SNF-8163
Revision 5

Performance Specification for the K East Basin Sludge Transportation System - Project A.16

ENGINEERING DOCUMENT CHANGE CONTROL

13. Change Description:
Direct Revision 5 to SNF-8163, Performance Specification for the K East Basin Sludge Transportation System - Project A.16, which includes minor changes as listed below:

Figure 6-2 – T PLANT LIFTING HOOK FOR LARGE DIAMETER CONTAINER

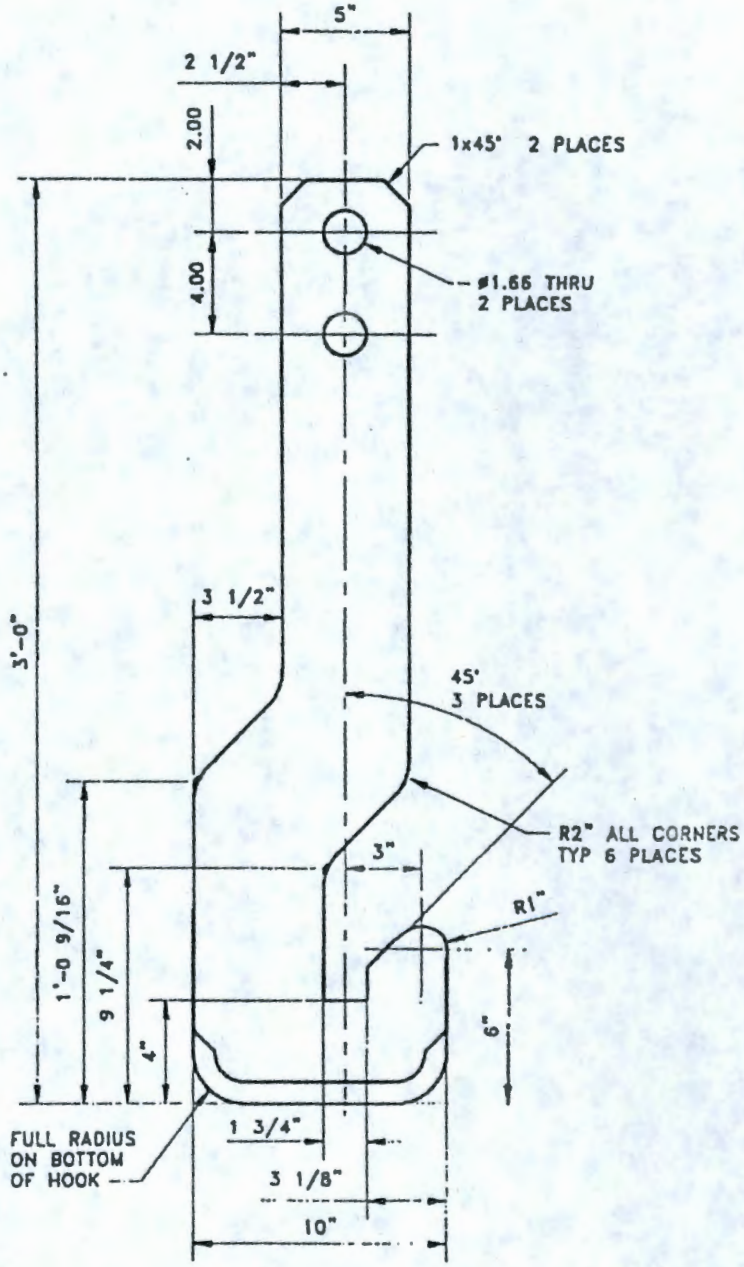
5.2.3.2	Revised worst case over-pressurization requriement to which the cask can be exposed to be limited by cask design.	Clarification.
6.1	2nd paragraph, 3rd sentence was revised to read T Plant dry "process" cells.	Clarificaiton.
Figure 6-2	T Plant Lifting Hook for large diameter container.	Requested by T Plant Operations.
